UNITED STATES PATENT AND TRADEMARK OFFICE

APPLICATION NO.	FILING DATE	FIRST NAMED INVENTOR	ATTORNEY DOCKET NO.	CONFIRMATION NO.
10/657,954	09/09/2003	Michael Crissy	EPH / 35	3045

Office Action Summary

ATTACHMENT 1

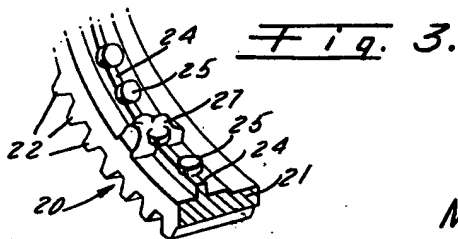
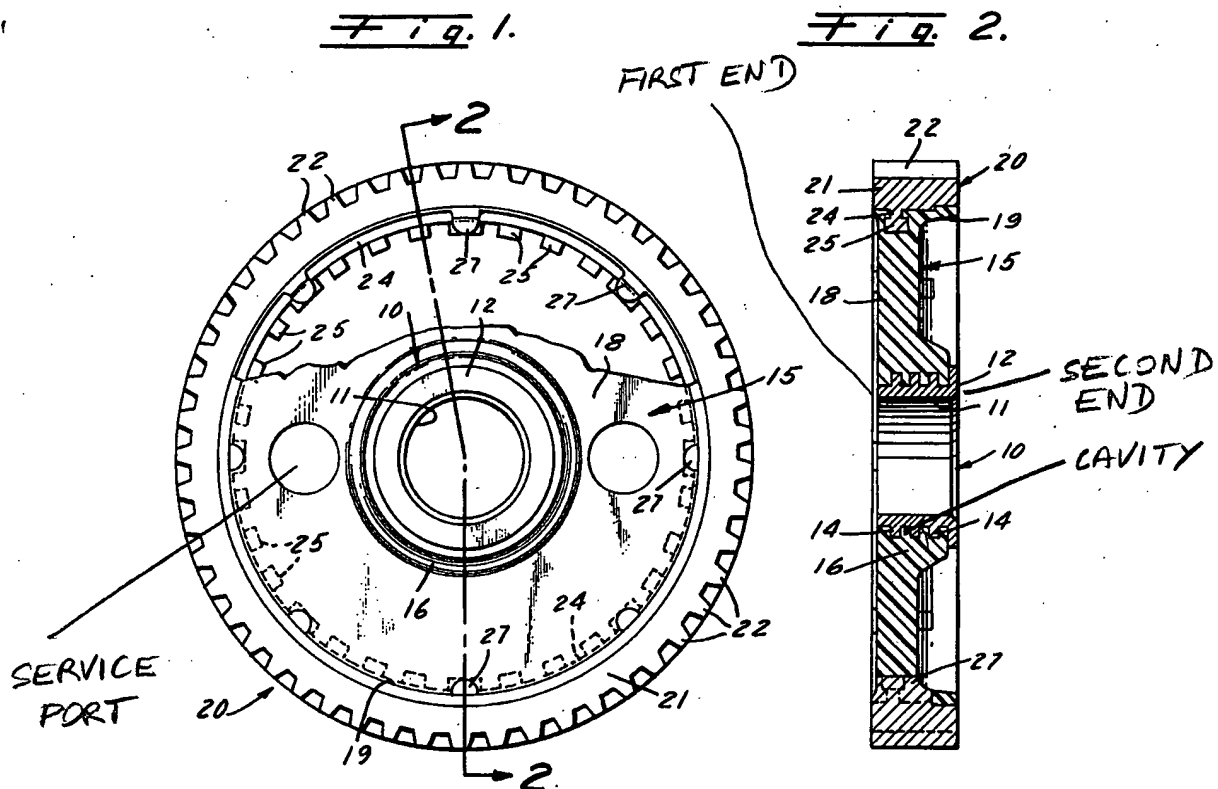
Regarding claim 1, Wells teaches a coupling structure mountable to a rotatable shaft (not shown) comprising: a polymer hub 18 having a plurality of service ports (unnumbered in Fig. 1. See Attachment 1); and a metallic insert 10 disposed radially inward from said polymer hub 18,

said metallic insert 10 including a tubular sleeve 41 extending between a first end (Att. 1) capable of being mounted to the rotatable shaft and a second end (Att. 1) opposite said first end, and an annular insert flange 12 (Fig. 2) projecting radially outward from said second end, said insert flange 12 being accessible through said plurality of service ports (Att. 1) for applying a force to said insert flange 12 capable of removing the coupling structure from the rotatable shaft when mounted thereto.

Regarding claim 8, said sleeve 11 includes at least one annular concavity (unnumbered). The concavity is located between two teeth 14. See Att. 1) filled with material from said polymer hub 18 for preventing relative rotation between said metallic insert 11 with said polymer hub 18.

Regarding claim 17, Wells' sleeve 11 includes at least one annular concavity (Att. 1) filled with material from said polymer hub 18 for preventing relative rotation between said metallic insert 11 with said polymer hub 18.

ATTACHMENT 2

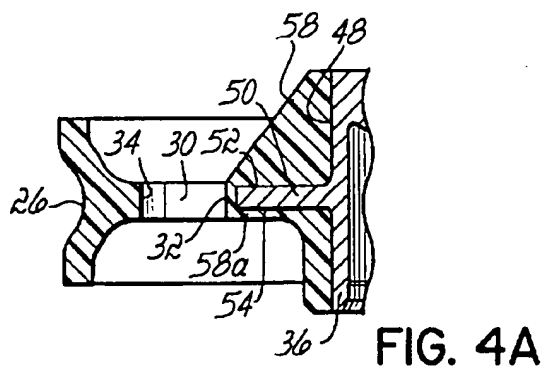
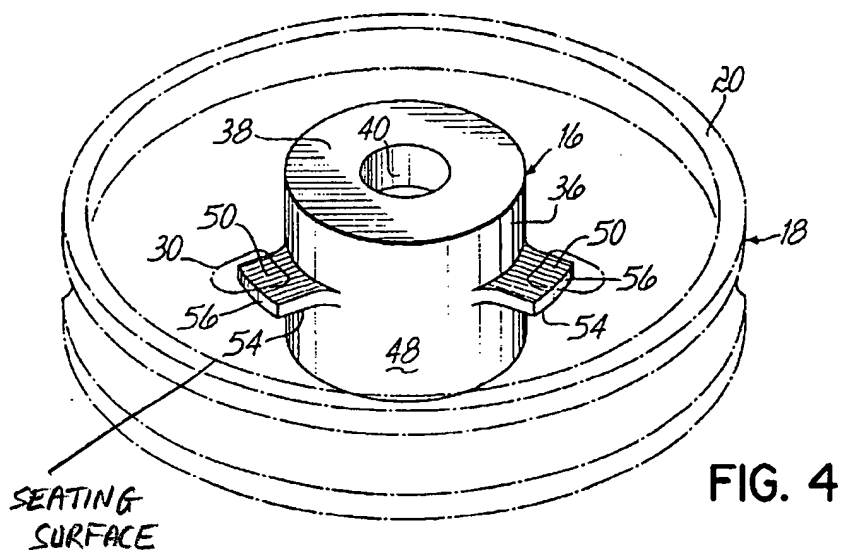
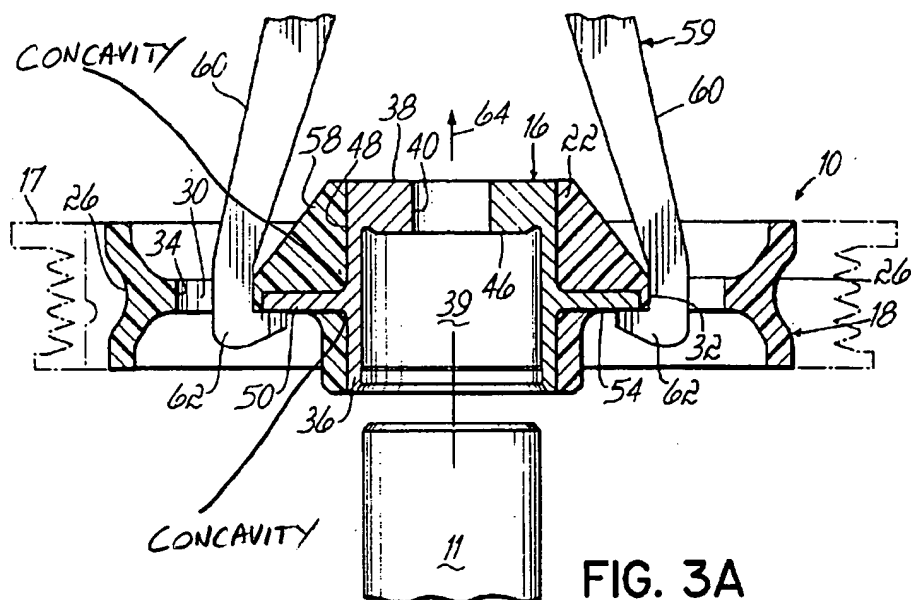
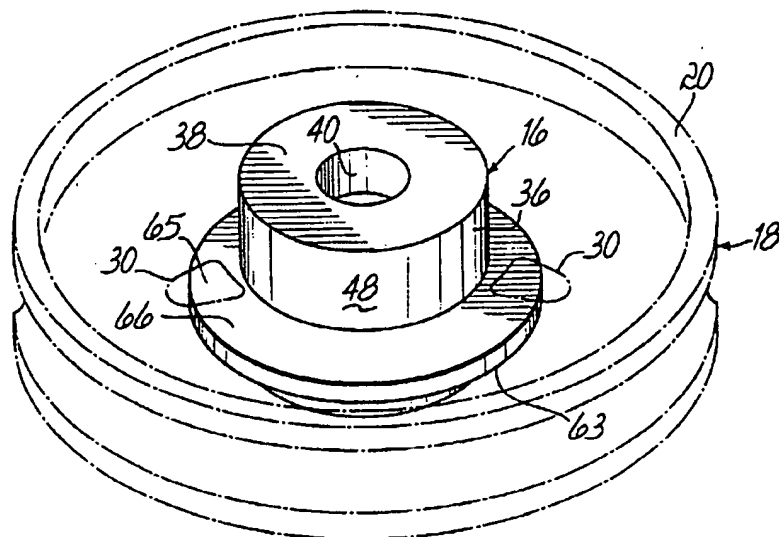
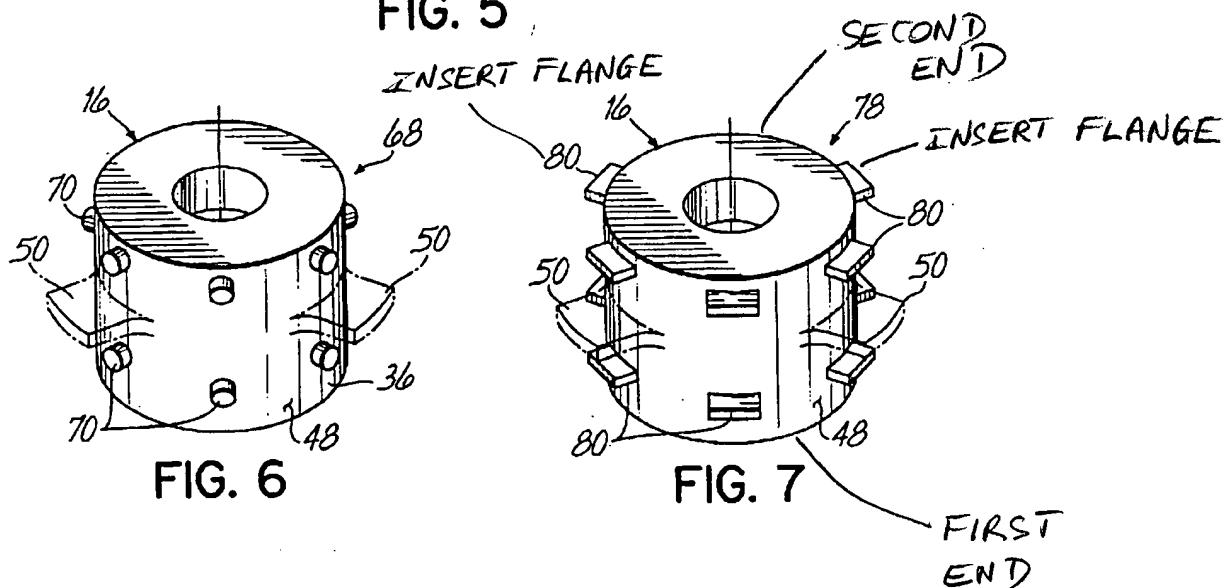
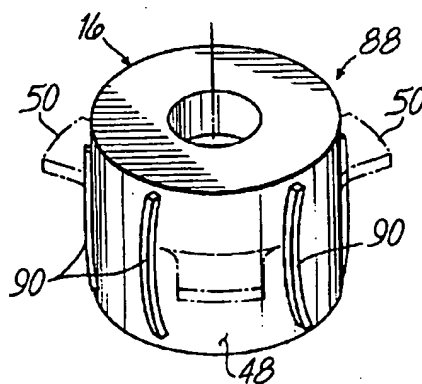
Regarding claim 8, said sleeve 48 includes at least one annular concavity (unnumbered. See Attachment 2) filled with material from said polymer hub 18 for preventing relative rotation between said metallic insert 16 with said polymer hub 18. Note that *Webster's II New Riverside University Dictionary*, 1994, defines "concavity" as "a concave surface, structure, or line." Thus, Nichols' concave surface or line "reads on" Applicant's "concavity."
